<b>AMENDMENT OF SOLICITATION/MODIFICATION OF CONTRACT</b>			1. Contract Number		Page of Pages 1 6		
2. Amendment/Modification Number 002		3. Effective Date See 16C		4. Requisition/Purchase Request No. RQ378470		5. Caption System Furniture/Workstations

**SUBJECT:** Questions and Answers Pertaining to DCPL-2008-I-0037  
**CAPTION:** Workstations/System Furniture

Amendment Number 2  
DCPL-2008-I-0037  
Workstations/System Furniture

# ATTACHMENT 1

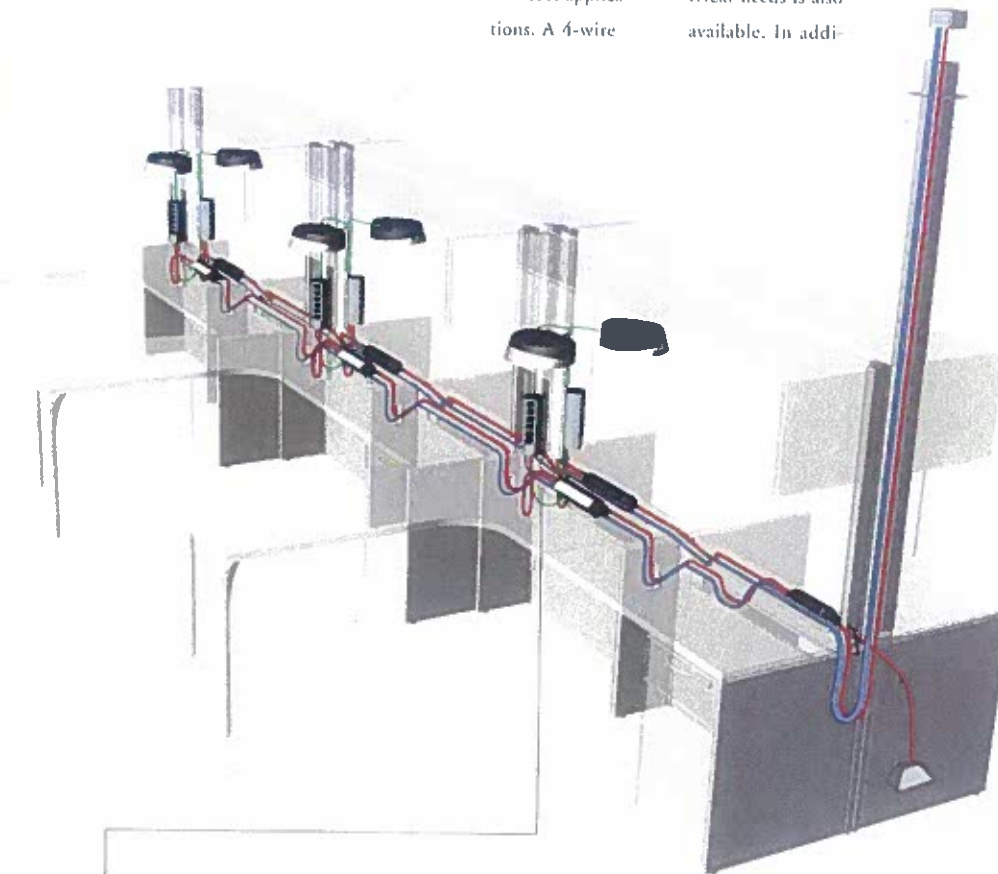
**Q1.** You have a product in bid called Optos which is a floor to ceiling item but the product is not listed as an item to bid on can you clarify this?

**A1.** The Optos should have been listed as items in the bid; we are placing them as an attachment to this question. **Please see attachment 1.**

Item	QTY
FYFP –ceiling top spacer anodized	87
Top spacer reveal // Linear Ft FYFC-ceiling frame beam	87
Ceiling frame beam // Linear Ft FYFB-Base frame & Channel Assembly B Max Leveling	63
Average base frame & double channel b // linear Ft FUFTC –Ceiling Horizontal Trim	63
Average ceiling horizontal trim FYFTB-Glass Kit	63
Tempered std glass clear 103-108"h 28"-30"w SHGD-Single hinged glass door	26
42"w Clear tempered glass single hinged door COOP-Corners & Connectors OPTOS connections 2 way 90 degree	7
Wall starter	1
IT-Installation tools	12
Silicone tape roll, wrench, silicone touch-up kit	1
Ceiling clips-for acoustic tile ceilings only	1
